North Addition to Grandview Commons Phase 10
Addendum No. 1
Contract: 9094, Project: 13854

North Addition to Grandview Commons Phase 10

Addendum No. 1

Contract: 9094, Project: 13854

13854
P-1

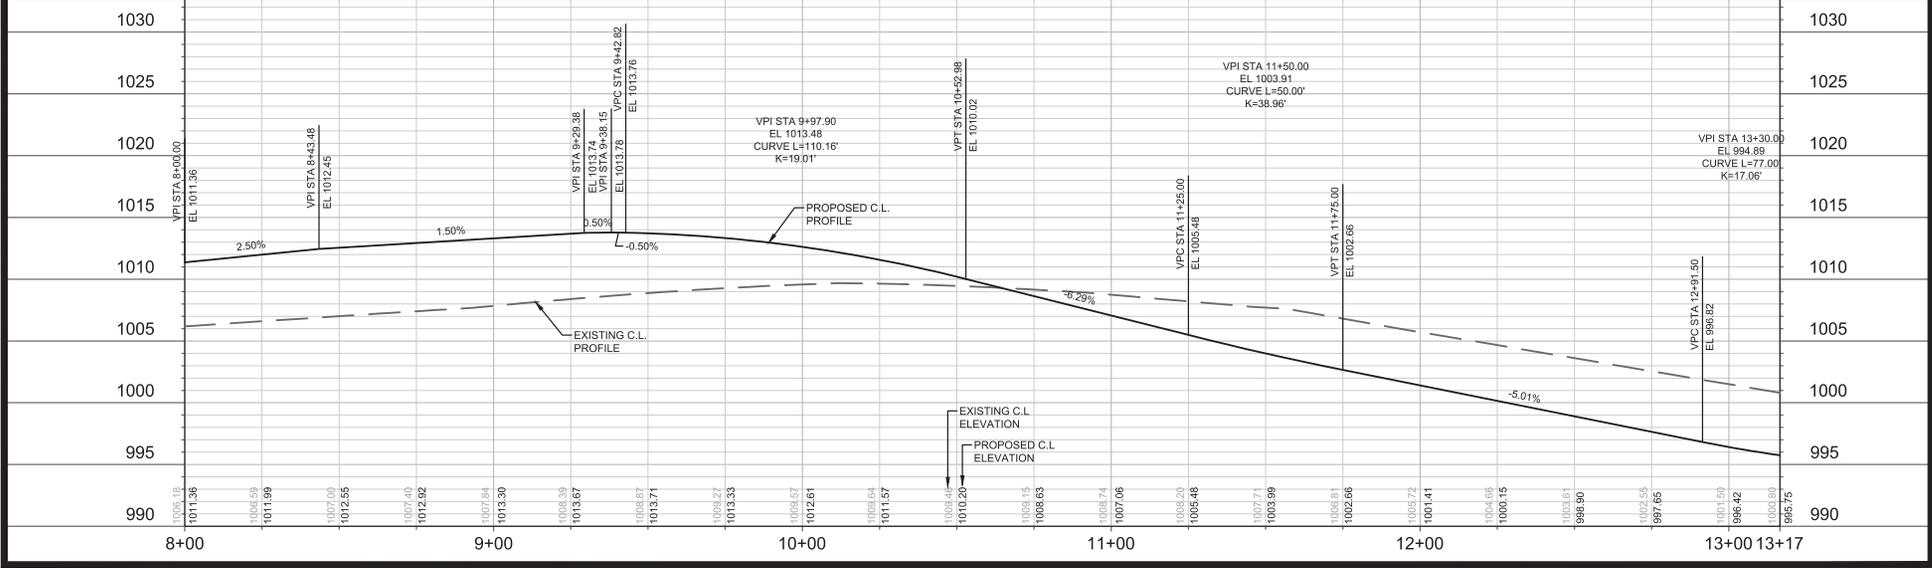
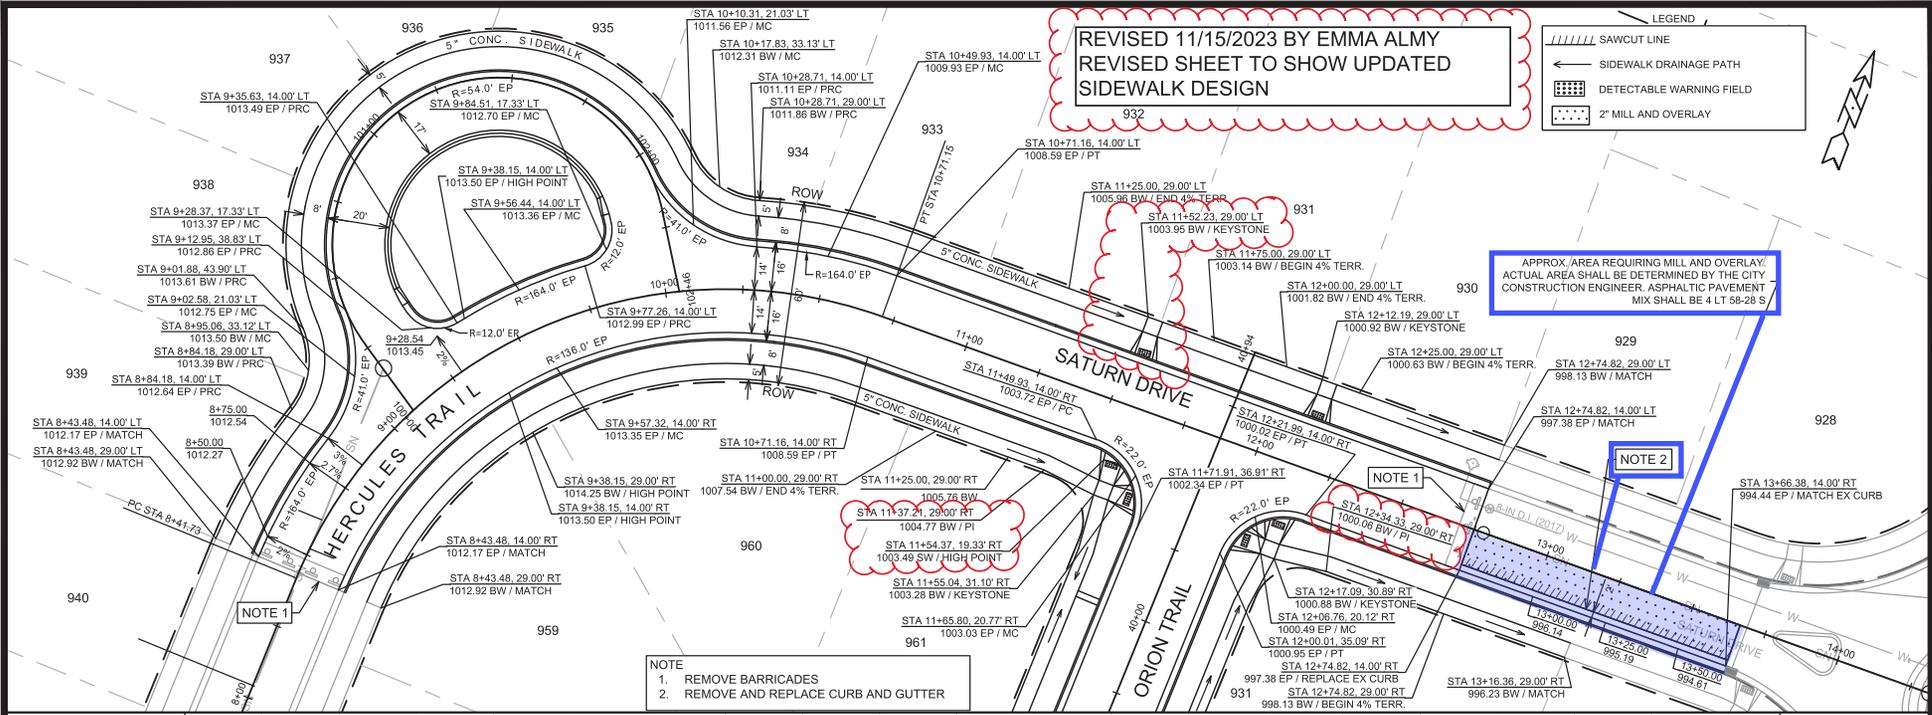
Addendum No 1 showing the pavement patch on Saturn Drive.

- Remove and replace existing curb and gutter, approximately 100 LF.
- Repair asphalt paving per City of Madison Pavement Patching Criteria to centerline of Saturn Drive.
- Install new 12" storm sewer pipe.
- The City shall reimburse the developer up to \$12,000 for the cost of the curb and gutter removal and asphalt pavement repair.

13854
 MADISON, WI
 CONTRACT NO.: 9094
 SATURN DIVE - UTILITIES PLAN & PROFILE
 NORTH ADDITION TO GRANDVIEW COMMONS PHASE 10
 M:\DESIGN\Projects\13854\CAD\Sewers\13854SWR-PipeNetwork.dwg
 13854
 U-1

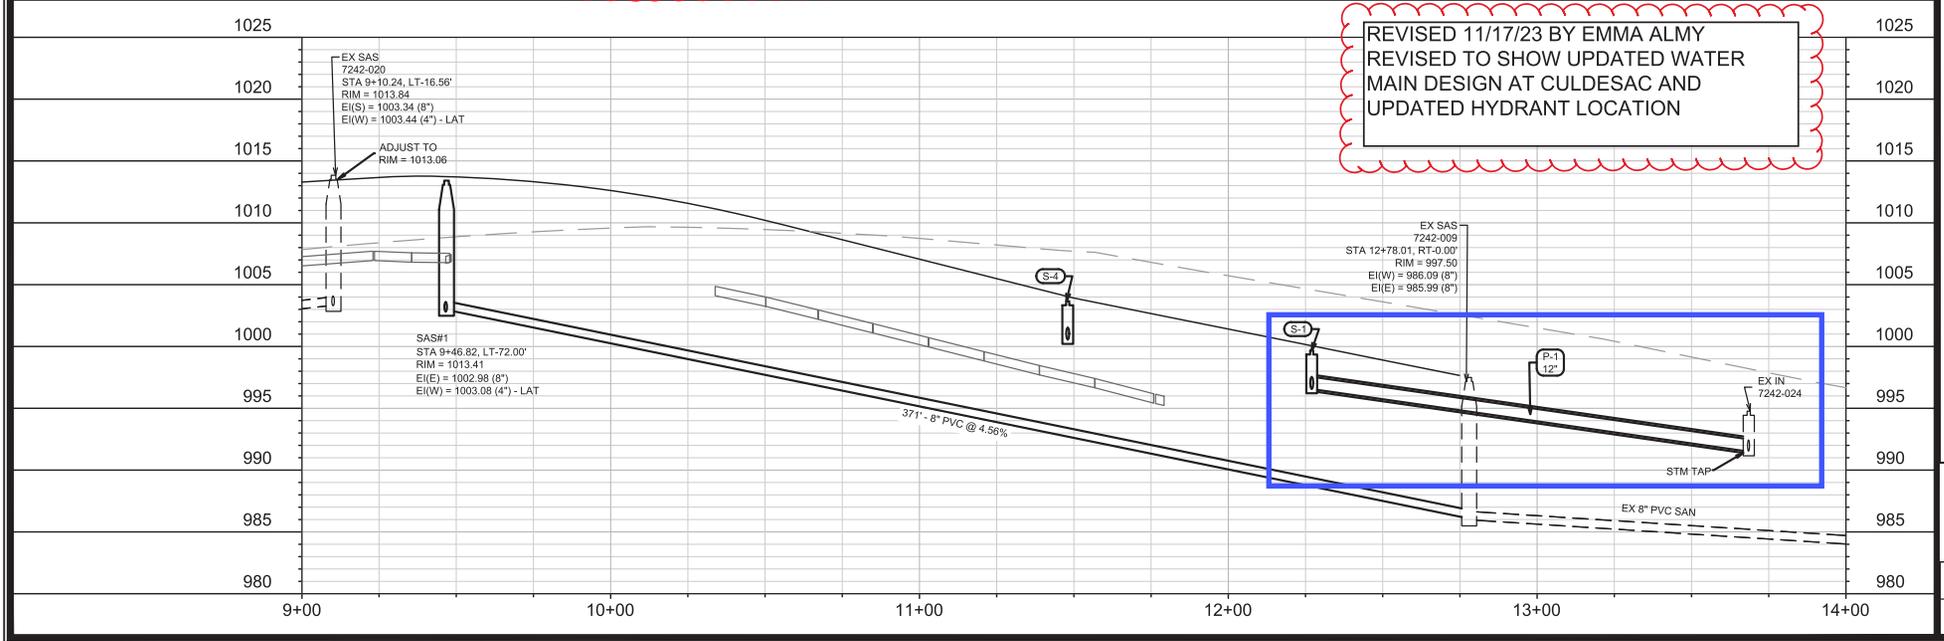
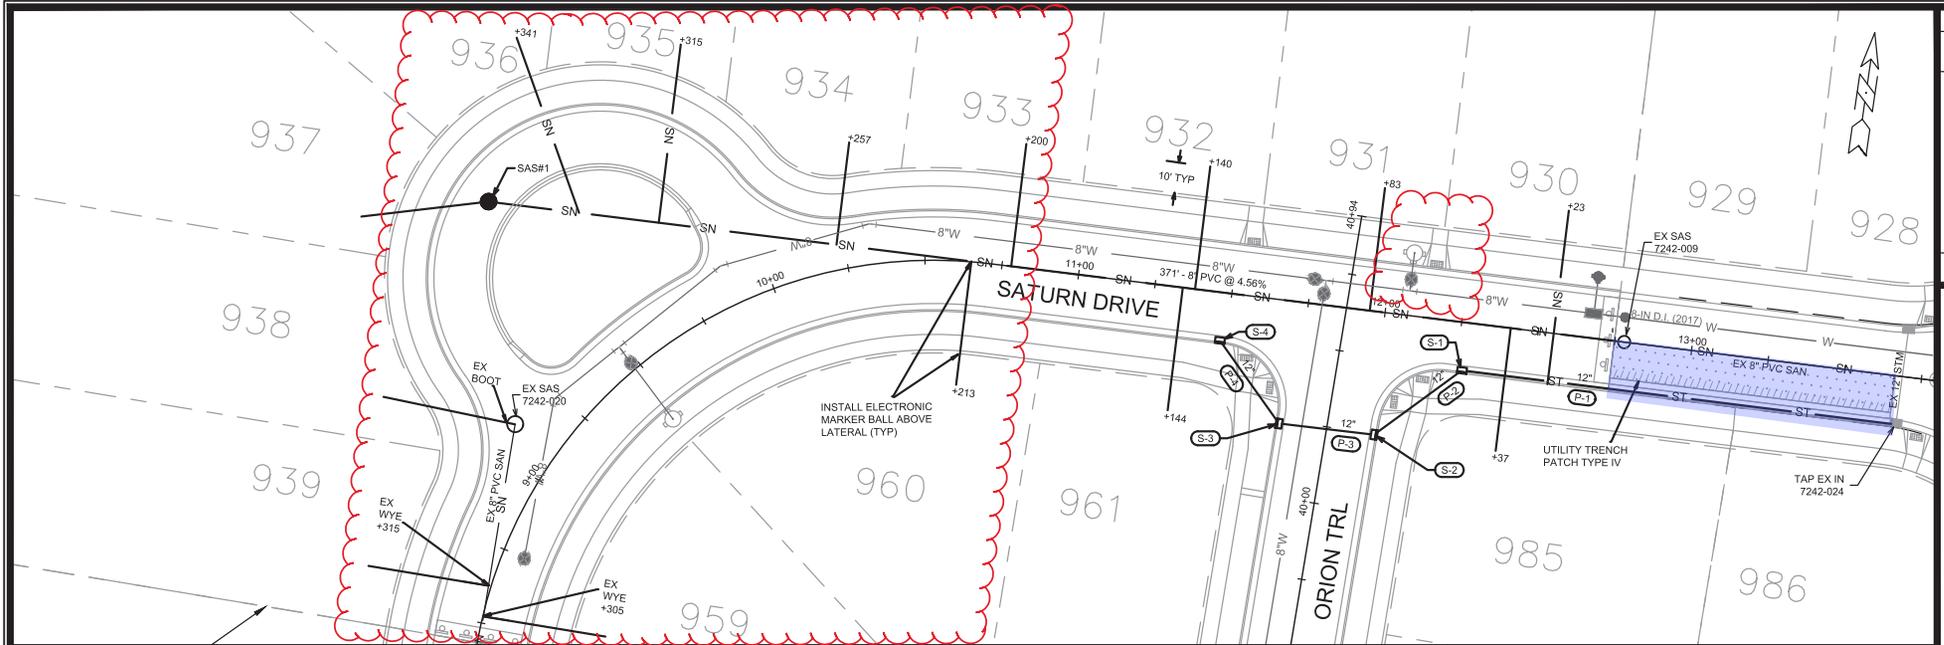
Addendum No 1 work showing profile of new public storm sewer and the pavement patch.

Developer to connect new public storm sewer to existing storm sewer outside of project limits at the intersection of Milky Way and Saturn Drive. The new storm sewer connection for Phase 10 could be installed under the curb line, which would require the removal/replacement of curb/gutter and asphalt restoration work or in the terrace without disturbing the existing street.

The determination is to install the storm sewer in the typical location under the curb and gutter. This option also allows for the planting of two additional terrace trees that would otherwise not be allowed with storm sewer in the terrace.
